SERVICE BULLETIN

BOEING 747

Bulletin No. 60-703-28-33
Revision 2, 2003/02/17
H/A 8-160 & 8-272
ATA 28-31

FUEL – MODIFICATION OF FUEL OVERRIDE JETTISON PUMP HOUSING SUBASSEMBLIES PART NO. 60-703200, 60-70304, 60-70305, 60-72314, 60-703135 (BPN 60B92603-21, -2, -5, -19, -20), TO PART NO. 60-703200-1, 60-70304-1, 60-70305-1, 60-72314-1, 60-703135-1 (BPN 60B92603-25, -102, -105, -119, -120), USED ON 747 / 747-400 AIRCRAFT.

**Typical Pump Housing
Figure 1**

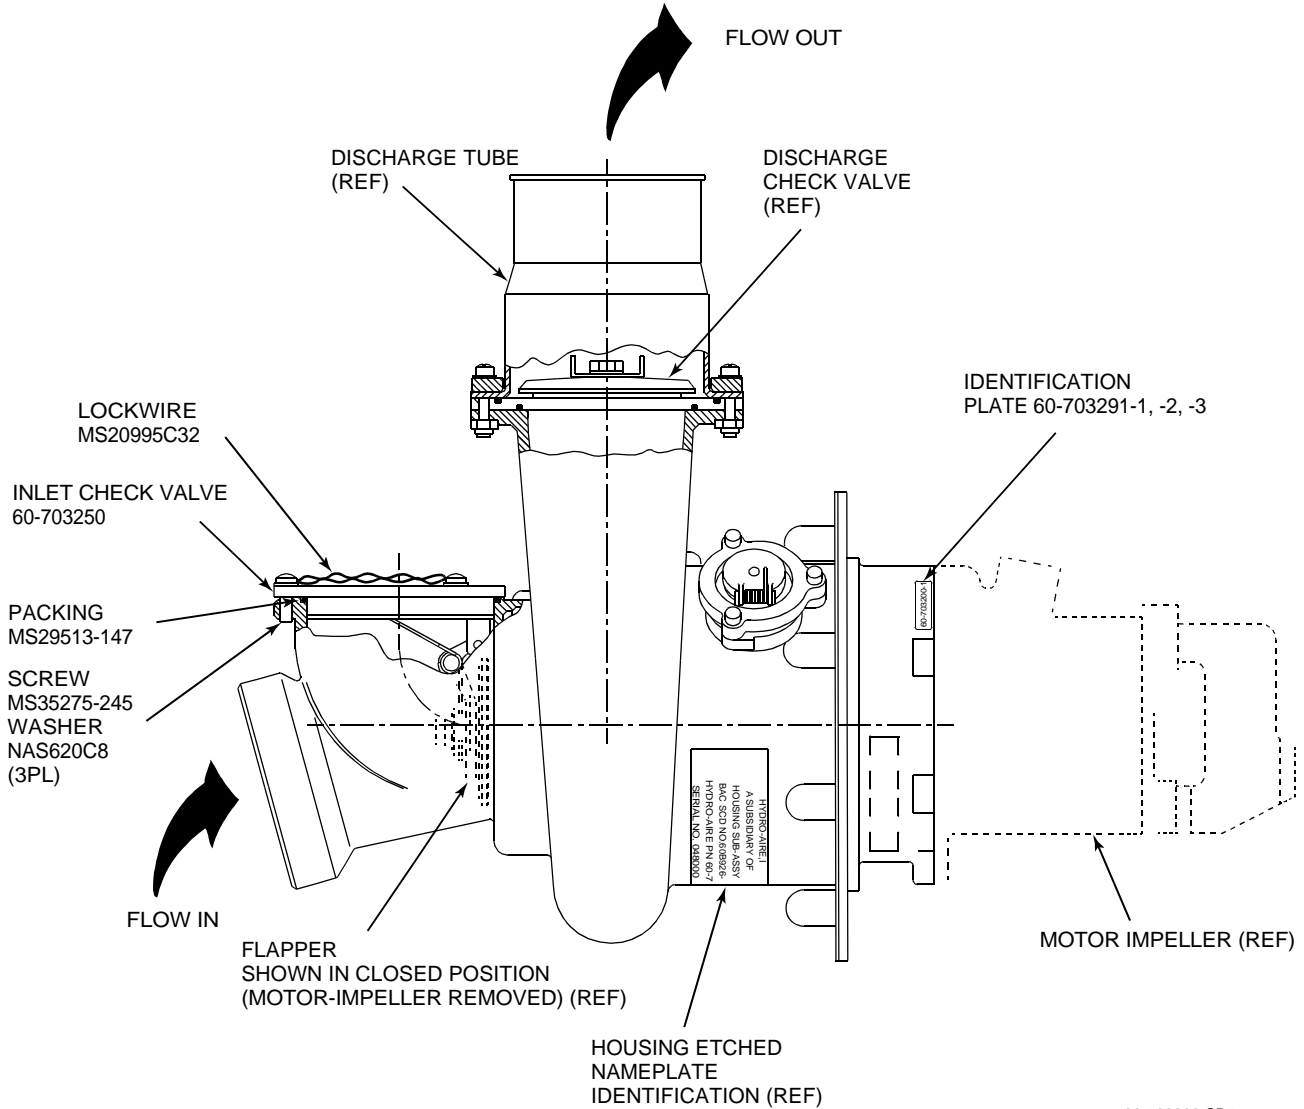
Excessive wear of the inlet check valve against the override/jettison pump inlet adapter has been reported. Vibration of the inlet check valve in the fuel stream can cause flapper deterioration, allowing pieces of the inlet check valve to be ingested into the pump's inducer/impeller. Wear to the motor impeller subassembly inlet adaptor also occurs at the point of contact with the inlet check valve.

This service bulletin gives instructions for the modification of Hydro-Aire Fuel Override/Jettison Pump Housing Subassemblies shown in paragraph 1.A. The resulting -1 configurations will include a new inlet check valve, P/N 60-703250, and identification plate, P/N 60-703291-1, -2, or -3 (see Figure 1).

- (5) Install the identification plate on the housing in the location shown in Figure 1.
- (6) Clean off excess adhesive and allow adhesive to cure as specified in BAC 5010, Rev. W, paragraph 8.2.40.

**Inlet Check Valve Assembly
Figure 2**

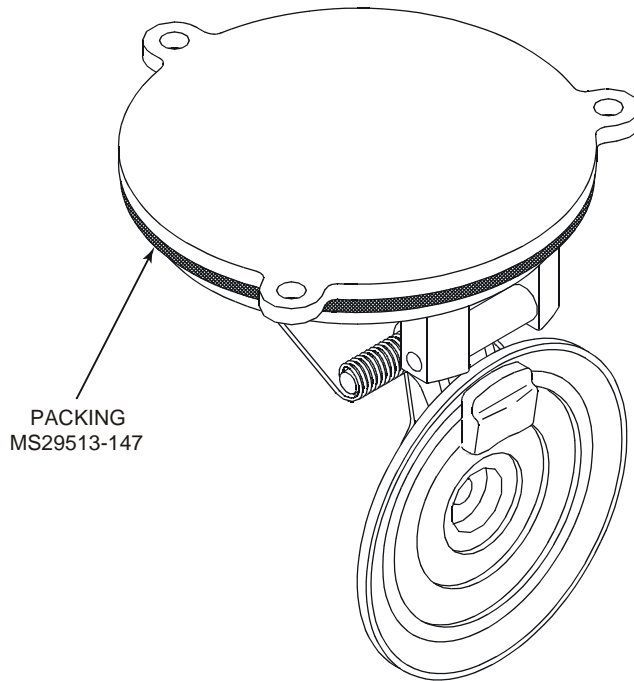
- (1) Refer to the DISASSEMBLY section in the applicable reference shown in paragraph 1.J. and remove the P/N 60-703137 inlet check valve and P/N MS29513-147 packing from the fuel jettison pump assembly housing P/Ns 60-703200, 60-72314, 60-70304, 60-70305, or 60-703135.
- (2) Install new P/N MS29513-147 packing as shown on the new P/N 60-703250 inlet check valve assembly (see Figure 2 below).
- (3) Use three P/N MS35275-245 screws and P/N NAS620C8 washers to attach the new P/N 60-703250 inlet check valve assembly to the P/Ns 60-703200, 60-72314, 60-70304, 60-70305, or 60-703135 pump housing.
- (4) Torque P/N MS35275-245 screws to 11–13 in.-lb (1.24–1.47 Nm) and safety wire screws with P/N MS20995C32 or MS20995C20 lockwire as directed in MS33540 (see Figure 1).
